APPENDIX C

Our Ref: 31977/111

Subject: Triangle - External works - Main entrance canopy

Made by: Checked by: Sheet No: 15 of

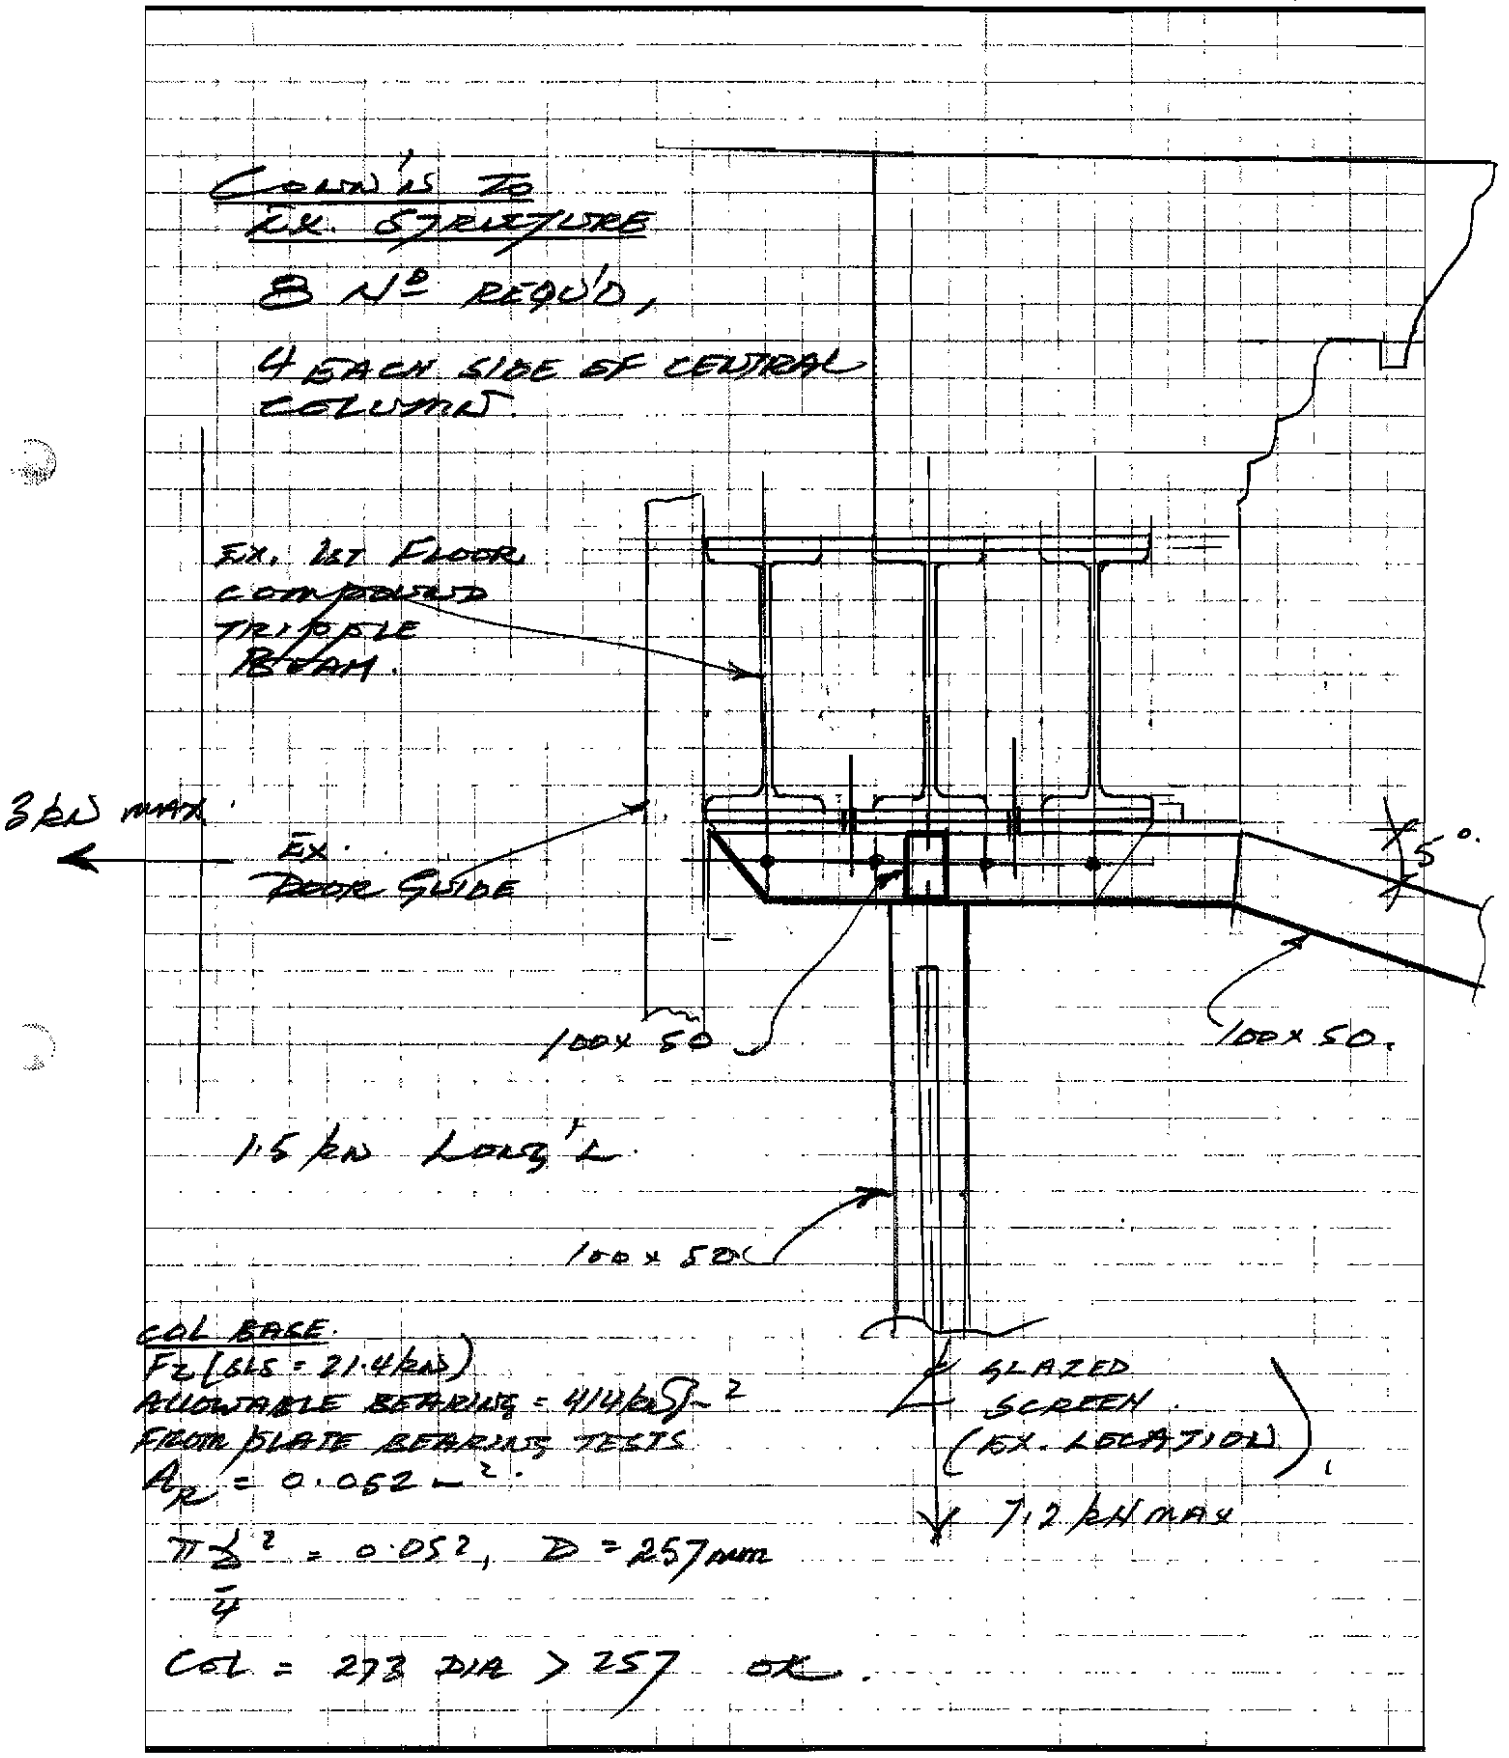
We have investigated the design of the main connection back to the existing first floor level compound steel beams. (Refer to the penultimate design sheet No. 20). This is the only structural zone available for connection other than taking support at the second floor level. The perimeter

The tie bar forces need to be transferred, via some tenuous bracketry, to the rear of the stonework, back to the triple compound steel beam section at first floor level. Access to the back of the stone is severely restricted by the roller shutter door mechanism and the tubular steel brace between masonry piers which cannot be removed. (Refer to attached photo's).

We are also unsure as to how the triple beam sections physically connect to the side and central columns. The significant torsion moments induced in the triple beams, from the canopy, will need to be transferred into and resisted by the building side columns which are currently embedded in masonry.

It is strongly recommended that alternative means of support be investigated to eliminate the need for the raking tie rods which induce the cantilever moment and torsion in the first floor level beams. This could be achieved by providing a pair of front posts thus eliminating the cantilever requirements at the building face. This is being investigated further.

FIGURE 1

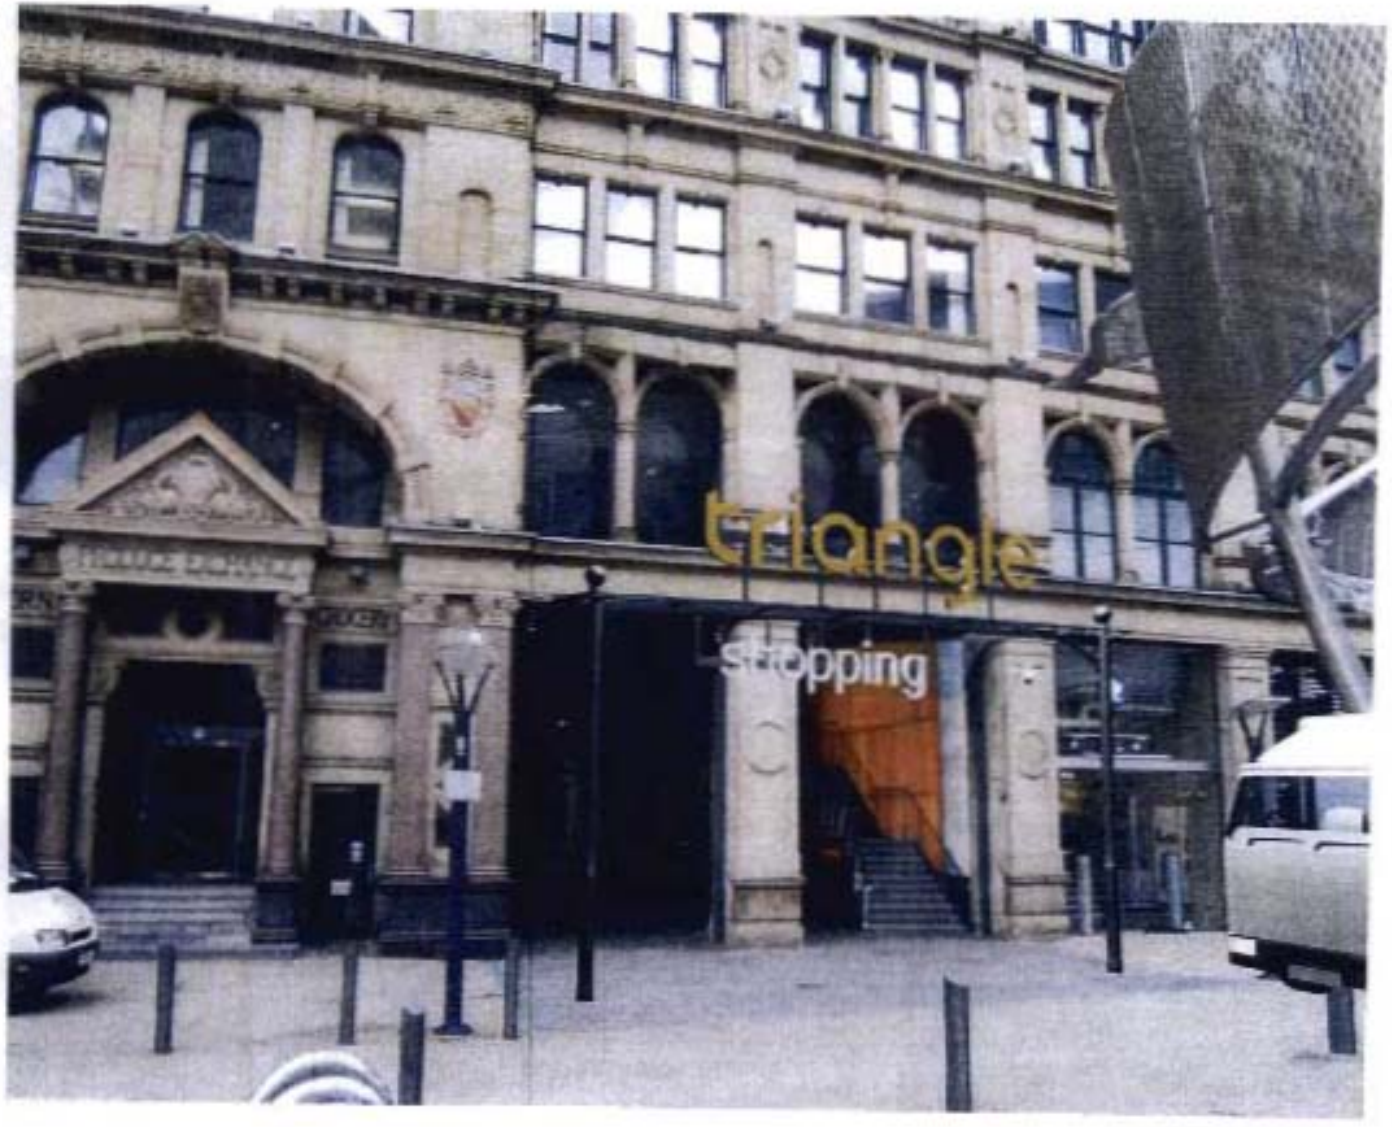
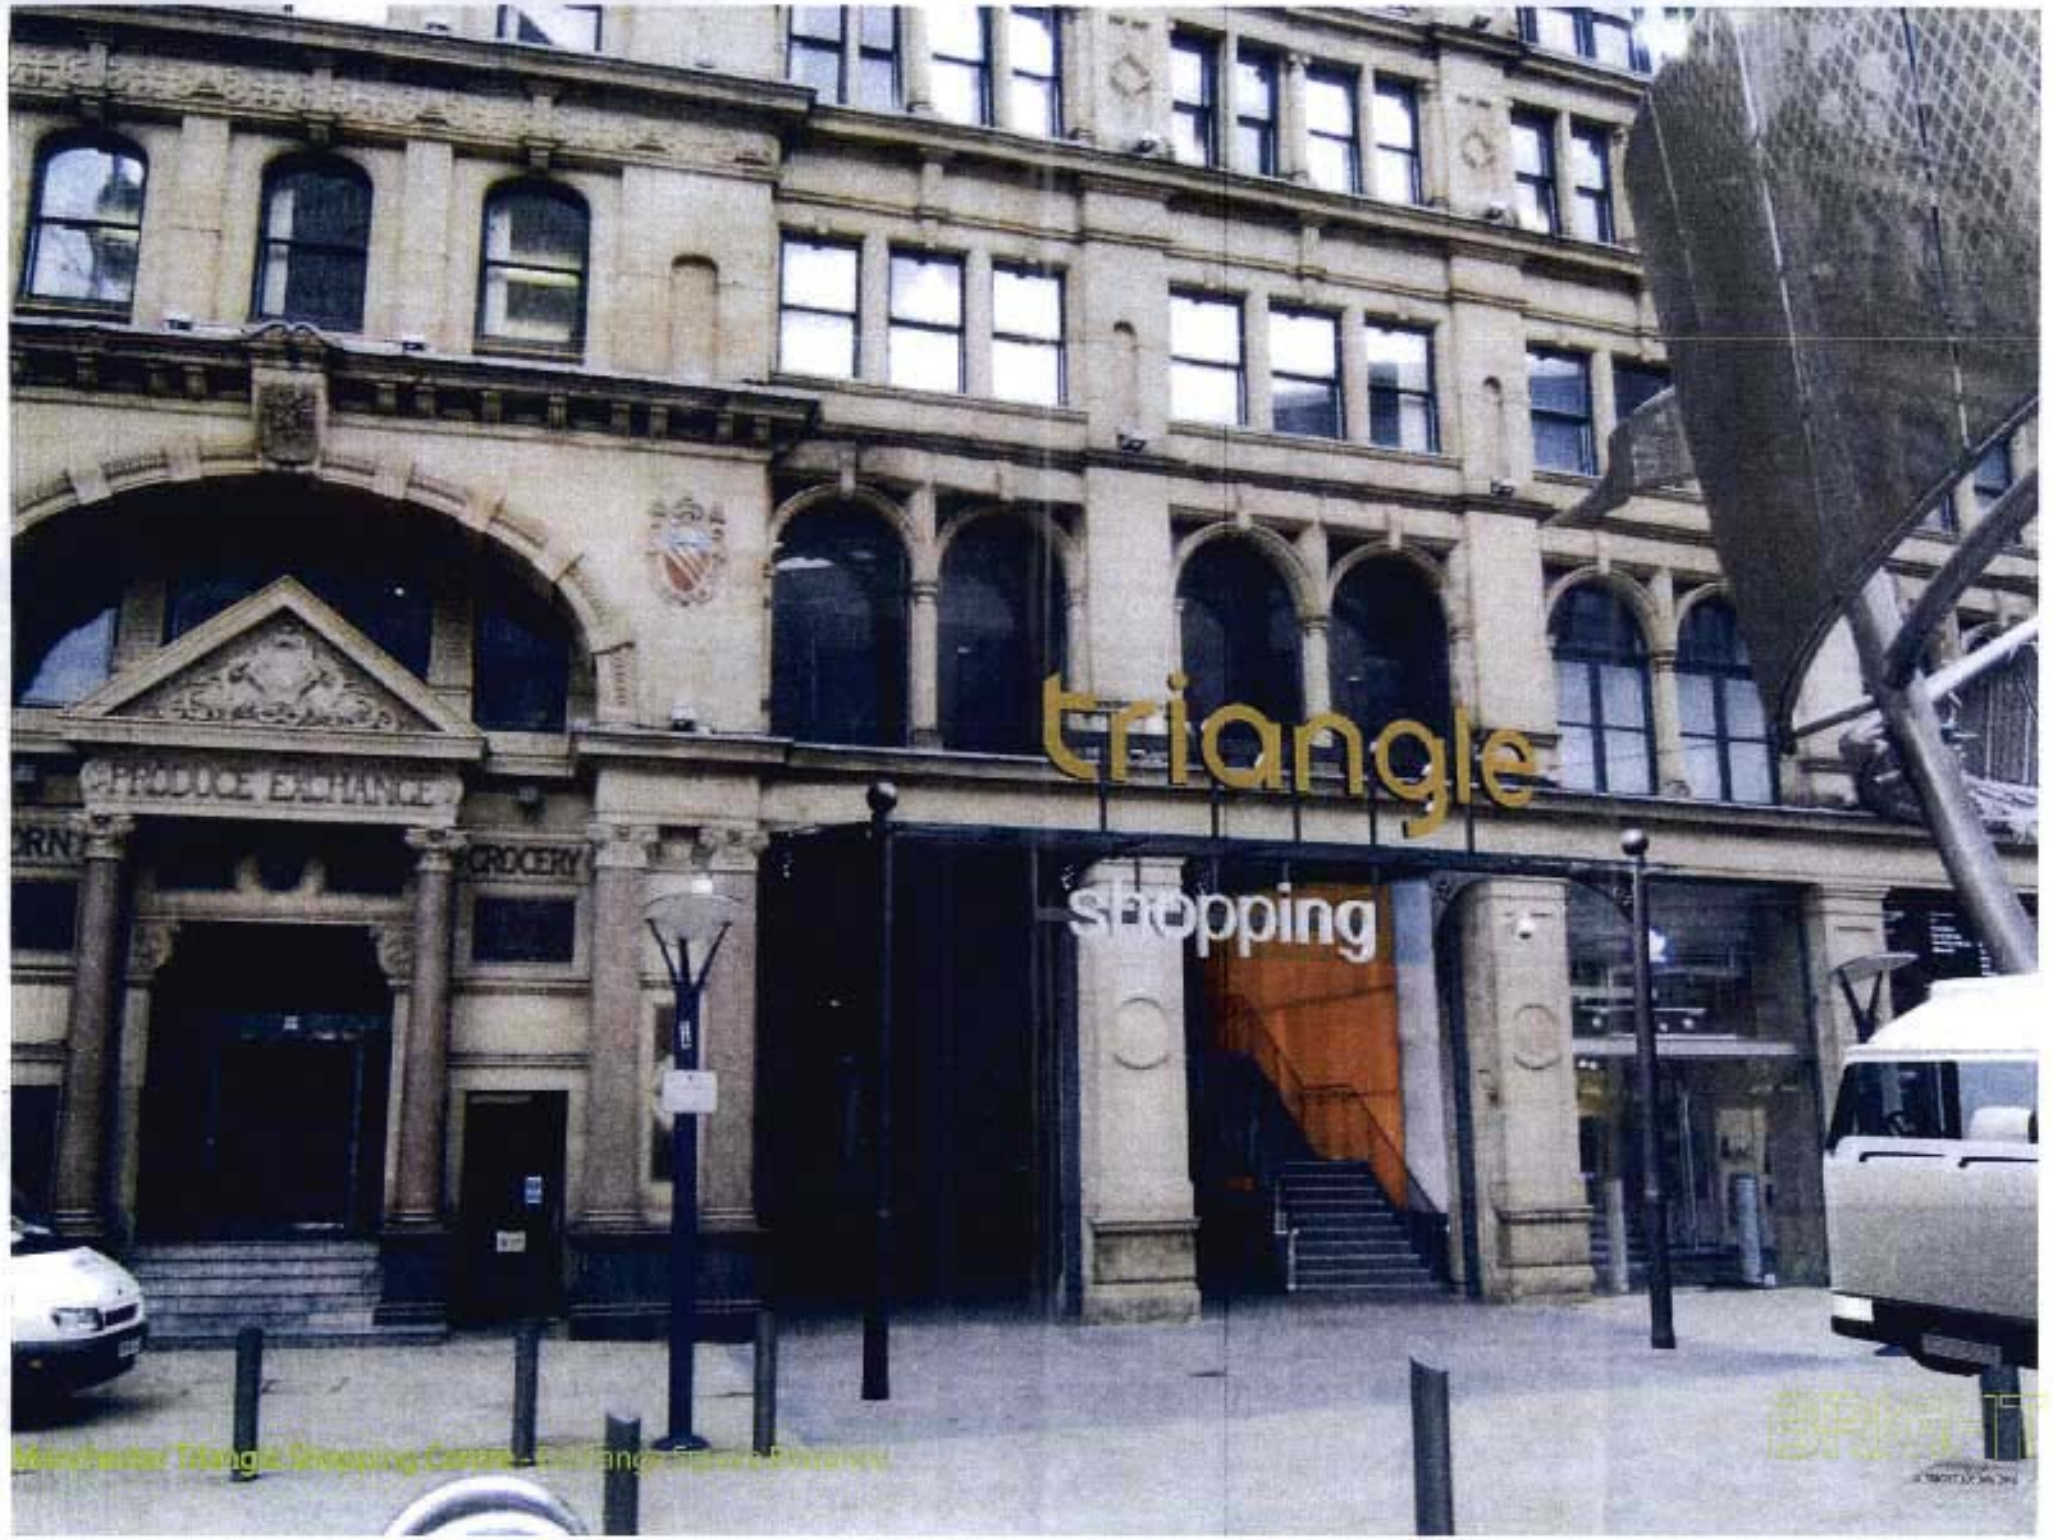
Having seen the pictures of the proposed changes to the entrance of the Triangle, I have no objections in principle. However as discussed, we would like bins with cigarette disposal units incorporated near to the entrance, and would like to have a say in the choice, this way keeping uniformity within the Public Realm.
